# PCN – Product Change Notification

PCN-A-110223

PCN Topic: Update 9 inches Open Frame Drawing\_W09L100-OFM1

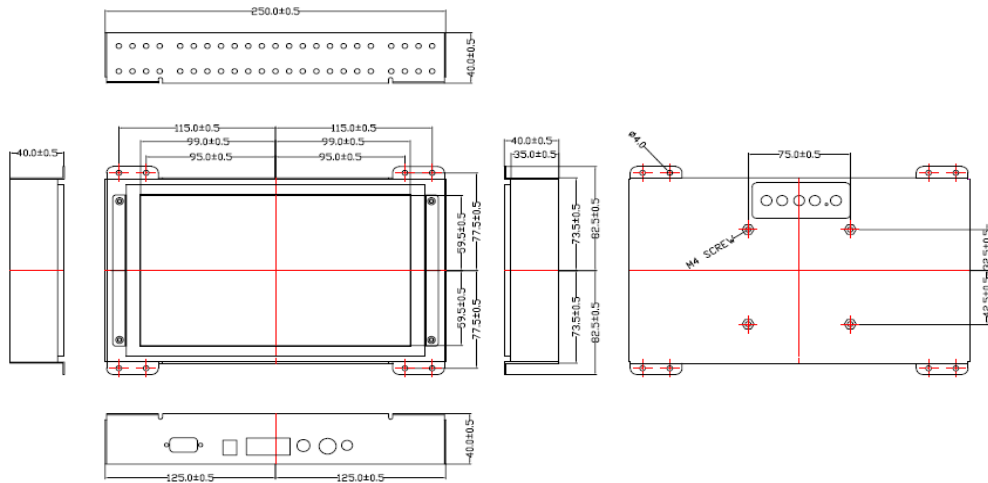
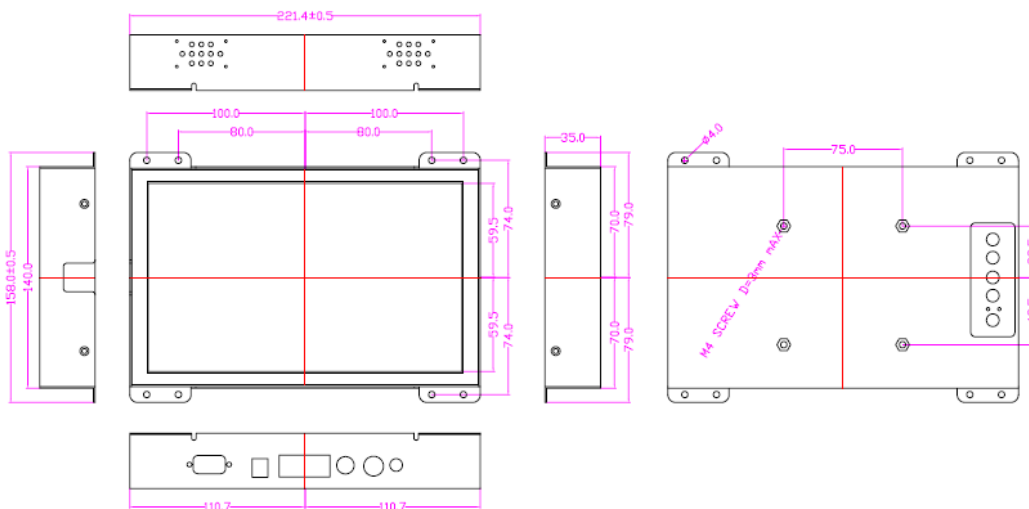
The dimension of this model will be change from 250\*165 (W\*D) to 221.4\*158 and brackets on both sides will be removed.
